PANEL REFERENCE	PPSHCC-335 - MA2024/00381 (PAN-482741)
LGA	Newcastle City Council
Proposal	Section 4.55(2) modification to DA2019/01169 for mixed use development, demolition of structures, erection of 14 storey mixed use including seniors living and aged care facilities - design changes to replace seniors living and aged care facilities with residential apartments
ADDRESS	124-126 Bull Street, Newcastle West (formerly known as 309 King Street, Newcastle West)
APPLICANT	GWH King Street Pty Ltd
OWNER	GWH King Street Pty Ltd
DATE OF LODGEMENT	5 November 2024
DOCUMENTS SUBMITTED FOR CONSIDERATION	<ul style="list-style-type: none"> • Attachment A - Response Letter prepared by Gyde • Attachment B - Fender Katsalidis Response Table • Attachment C - Part 1 - Solar Access Compliance Response prepared by Fender Katsalidis • Attachment D - Part 2 - Solar Access Compliance Response prepared by Fender Katsalidis • Attachment E - Part 3 - Solar Access Compliance Response prepared by Fender Katsalidis • Attachment F - Advisory Note prepared by the UDRP Chair • Attachment G - Amended Schedule of Conditions – changes shown in red • Attachment H - Amended Schedule of Conditions – clean set

This memo

Figure 1 Comparison of proposed balcony plan and amendments (left) and resultant solar analysis at 9am (right)

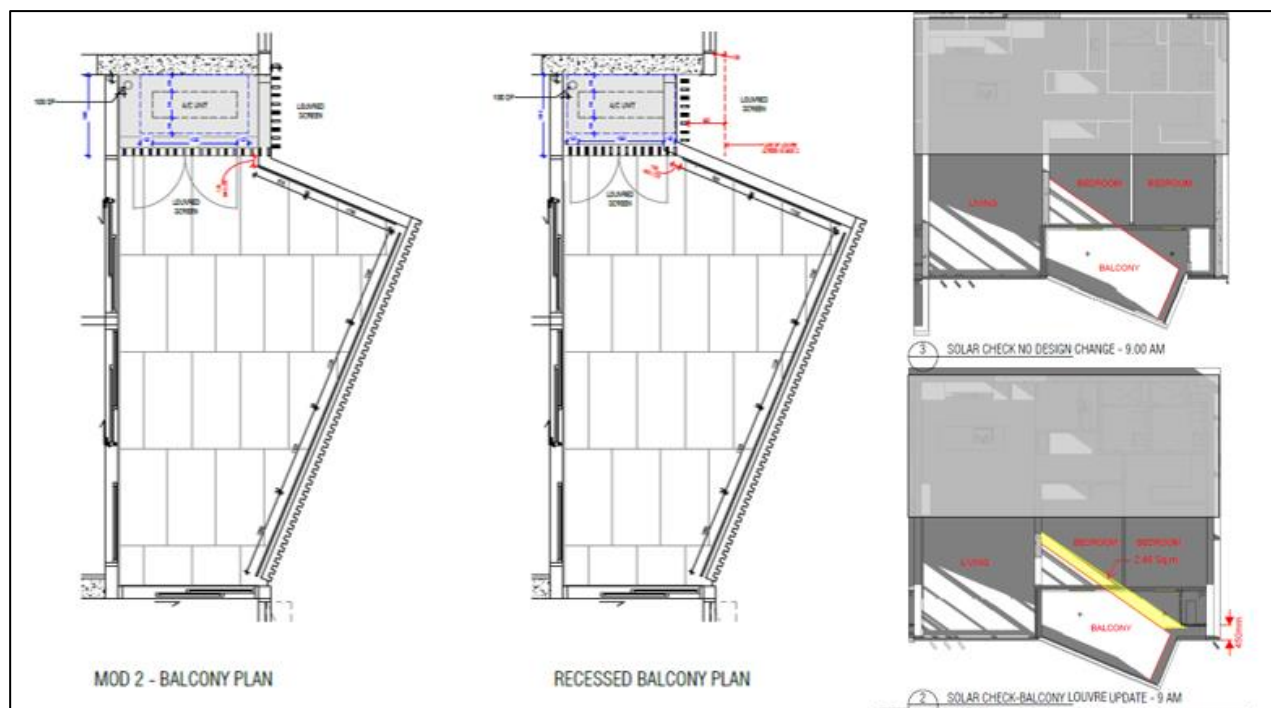
To the eastern façade of Tower B, the design changes include reducing the width of the air conditioning plant enclosures on each balcony by 450mm. This improves sunlight penetration into the bedrooms and living areas as shown below in **Figure 1** and in Part 3 Solar Analysis prepared by FK at **Attachment E**.

- The number of apartments receiving solar access to the private open space on the eastern façade of Tower B is optimised in the current modification compared to the original DA through an increase in balcony sizes and adjustments made to the AC plant enclosures. This allows for improved amenity and useability of the private open space areas for each apartment.

Figure 2 Proposed location of skylights and voids within existing parapets to filter light to Level 14 apartments

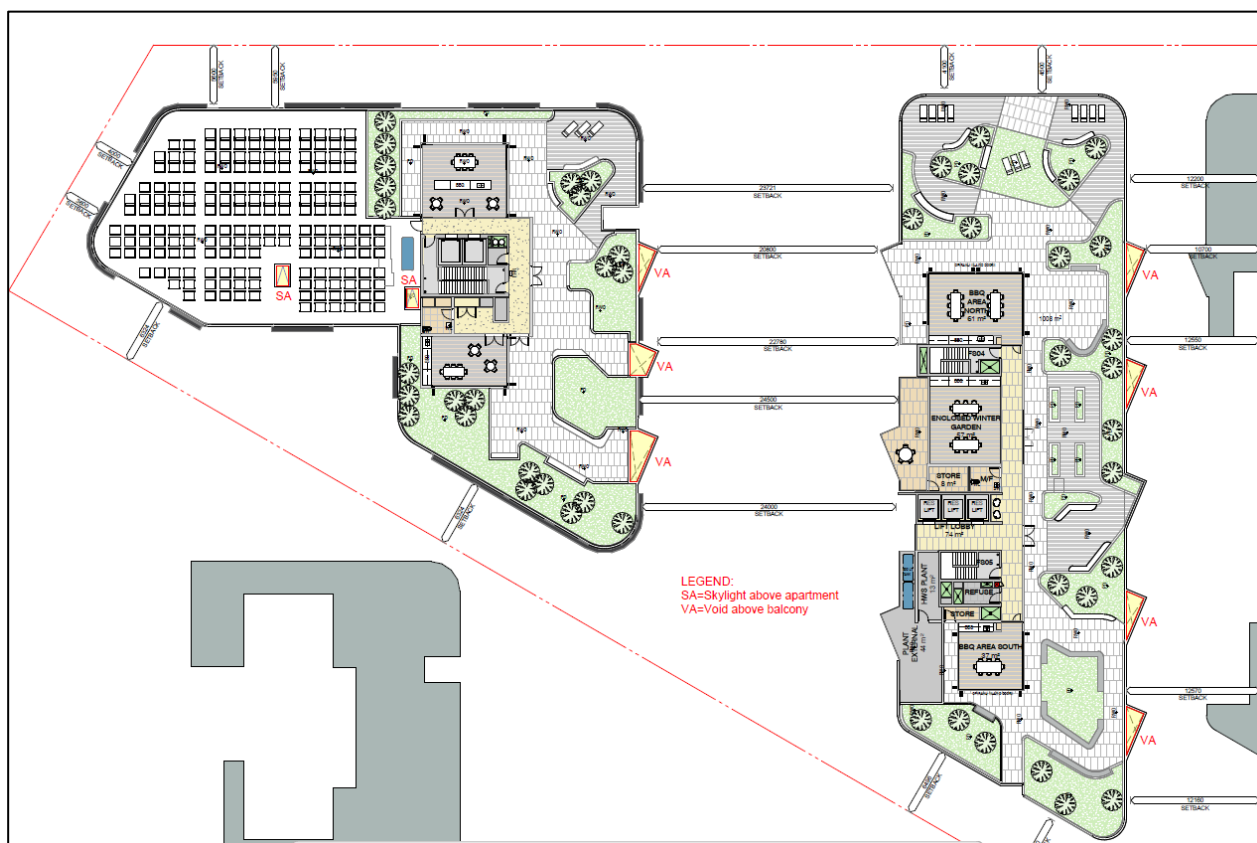
Previously submitted solar access analysis for Level 15 identified skylights to both towers ensuring all Level 14 apartments receive a minimum of 2 hours of solar access.

The proposal was revised following CN's concerns regarding the construction, placement, and effectiveness of skylights within rooftop communal open space areas. The amended design now incorporates voids within the existing parapet profile to enhance sunlight for three apartments on the eastern façade of Tower A and four apartments on the eastern façade of Tower B. In addition, two skylights are proposed for south-facing apartments in Tower A. These skylights are not within the

communal open space areas. The proposed design amendment is shown at **Figure 2** and in Part 3 Solar Analysis at **Attachment E**.

- The number of apartments receiving solar access to their living areas on Level 14 is optimised through the reinstatement of two skylights and the provision of seven voids in the existing parapet of the roof form to enable sunlight to penetrate to the apartments below. This design measure does not alter the overall built form or quantum of communal open space and rather allows for 2 hours of sunlight to 19 out of the 20 apartments across Tower A and Tower B.

Figure 3 2018 concept design phase site massing prepared by FK

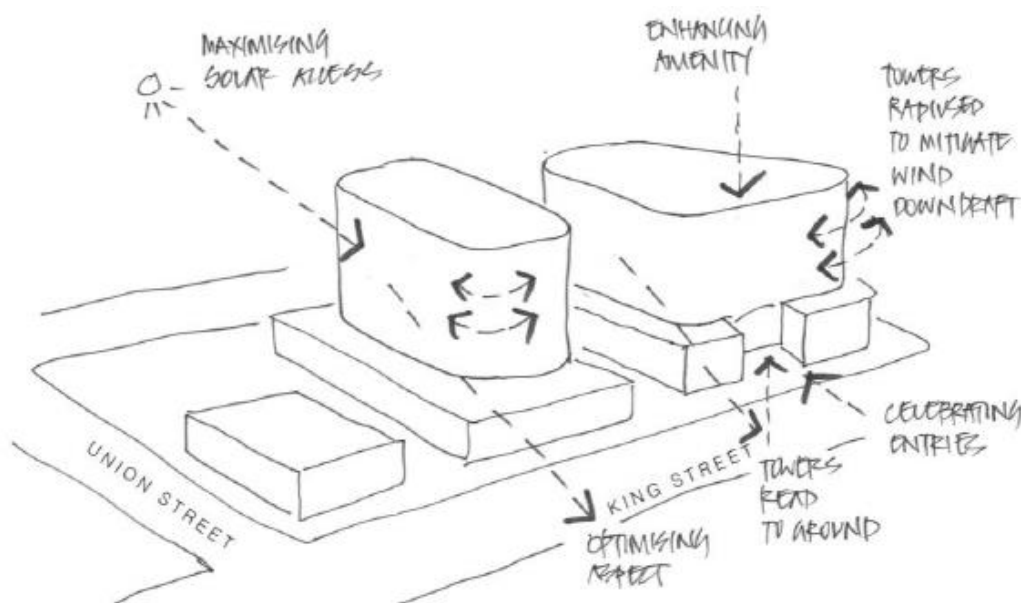
Noting the HCCRPPs comments on the site being a "relatively unconstrained corner site that has limited development scale proximate to it" the applicant provided options analyses of potential massing considered in the pre-DA meeting held in 2018 by FK shown in **Figure 3** below. The applicant states:

The applicant states if the correct solar angle had been known in the early design phase for the original DA, the eastern facades may have been rotated to optimise solar access, however this would have created an awkward alignment between the towers, podium levels and the relationship with the public domain and surrounding streets.
